UNITED STATES PATENT AND TRADEMARK OFFICE

Office Action Summary

10/672,355

DETAILED ACTION

Exhibit A

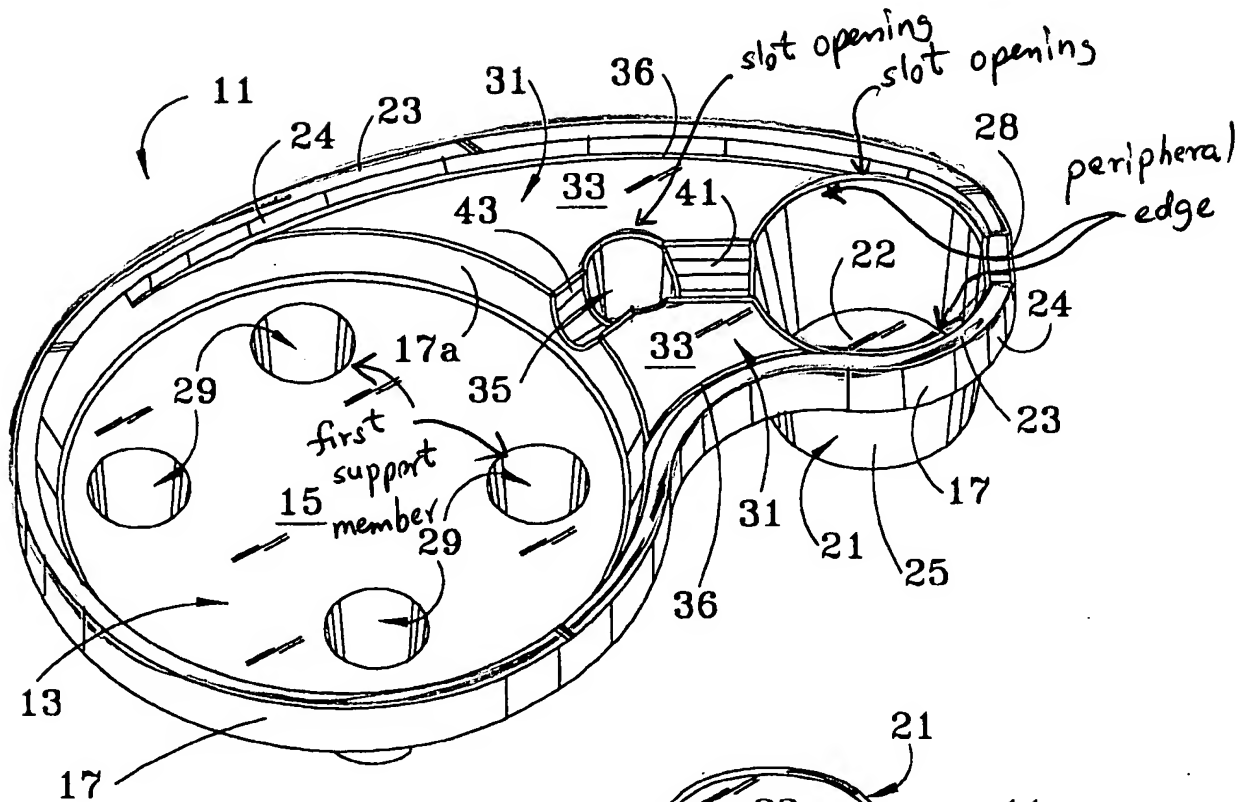
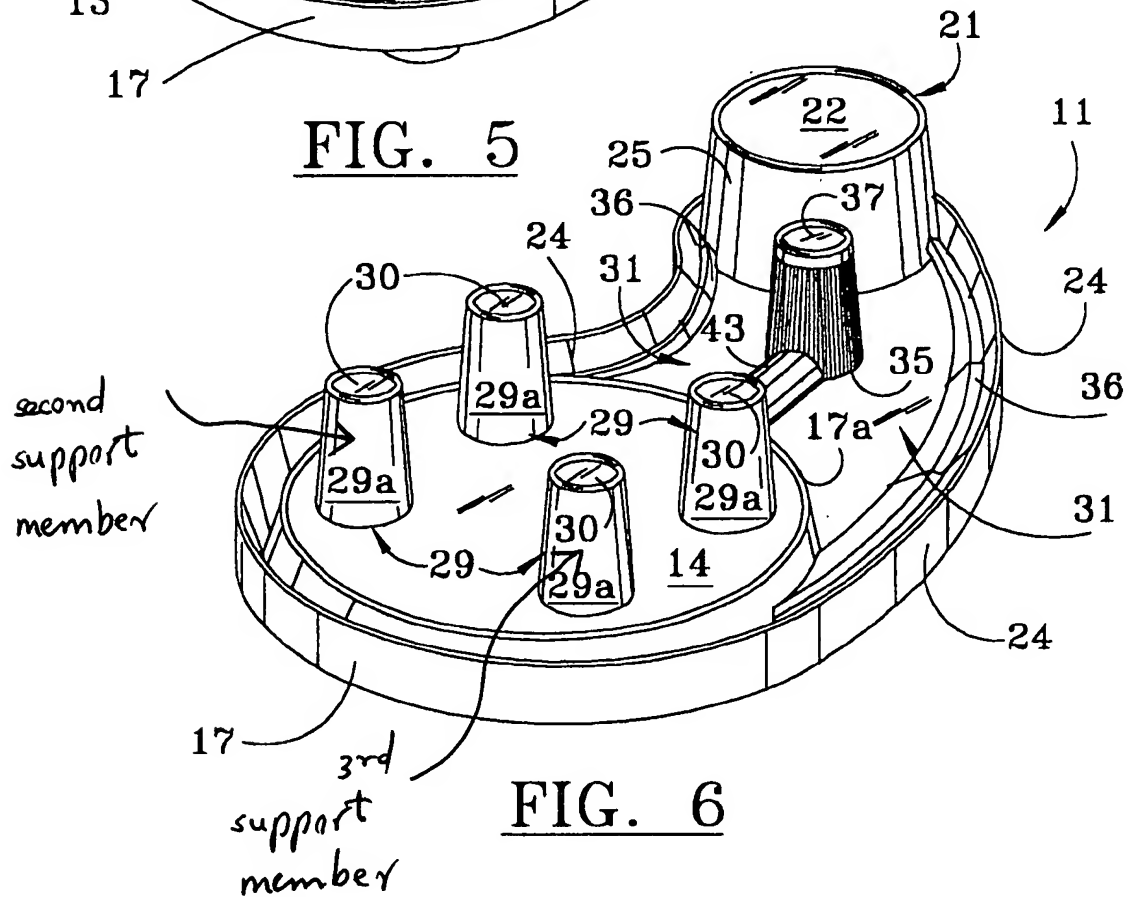
6. Claim 25, as best understood, is rejected under 35 U.S.C. 102(b) as being anticipated by Bradley (6,264,026).

Bradley (6,264,026) discloses a beverage holder (see Exhibit A) comprising a panel (15,33) having a peripheral edge (see Exhibit A), the panel having a plurality of slots openings at the peripheral edge, each of the plurality of slots extending from the peripheral edge (see Exhibit A), the panel having a top surface and a bottom surface, a support element extending downwardly from the bottom surface (15) of the panel (see Figs. 5 and 6), the support element comprising a first support member (29) (Figs. 5 and 6) extending downwardly from a central area, a second support member, and a third support member, wherein the each support member being tapered (Fig. 6) having a wide diameter at the bottom surface (Fig. 5) and a narrow diameter at the bottom (30) of the support member (see Fig. 6), and the bottom ends (30) of the support members are coplanar with each other and in parallel planar in relation with the panel (15) (lines 47-65 of Col 6).

Exhibit B

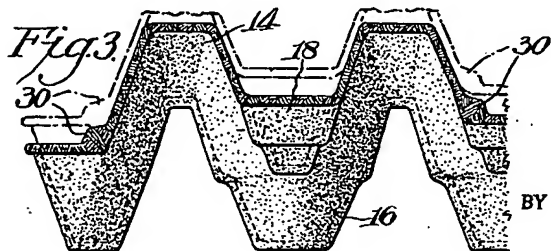
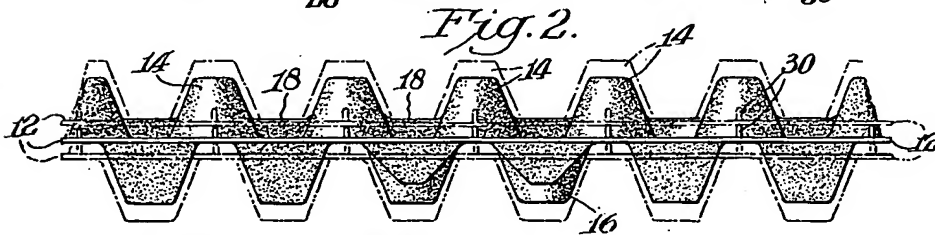
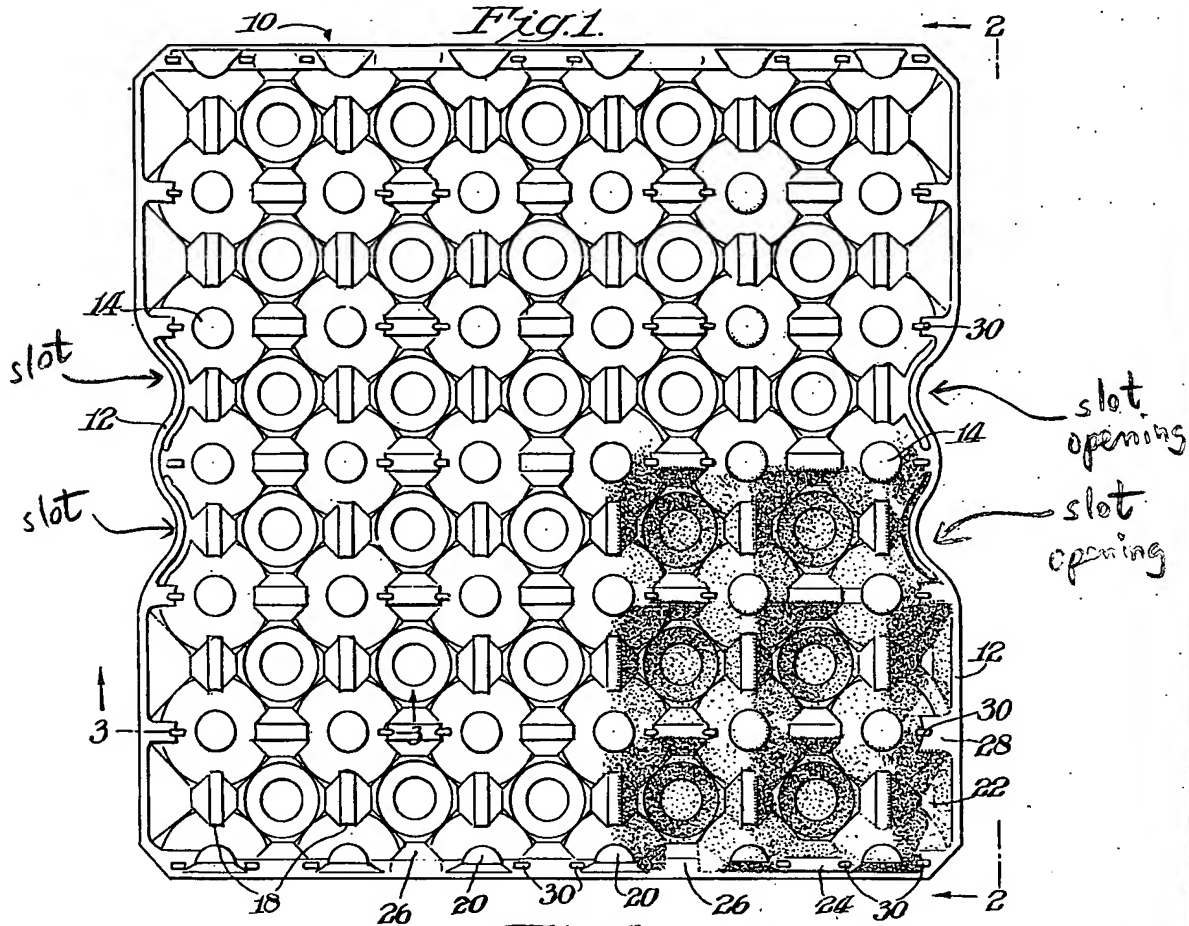
7. Claim 25, as best understood, is rejected under 35 U.S.C. 102(b) as being anticipated by Emery (2,997,196).

Emery (2,997,196) discloses a beverage holder (see Exhibit B) comprising a panel (Fig. 1) having a peripheral edge (12) (see Exhibit B), the panel having a plurality of slots openings at the peripheral edge, each of the plurality of slots extending from the peripheral edge (see Exhibit B), the panel having a top surface and a bottom surface, a support element extending downwardly from the bottom surface (Fig. 2) of the panel, the support element comprising a first support member (16) extending downwardly from a central area, a second support member (16), and a third support member (16), wherein each support member being tapered (Figs. 2 and 3) having a wide diameter at the bottom surface and a narrow diameter at the bottom of the support member (see Figs. 2

and 3), and the bottom ends of the support members are coplanar with each other and in parallel planar in relation with the panel (see Figs. 2 and 3).
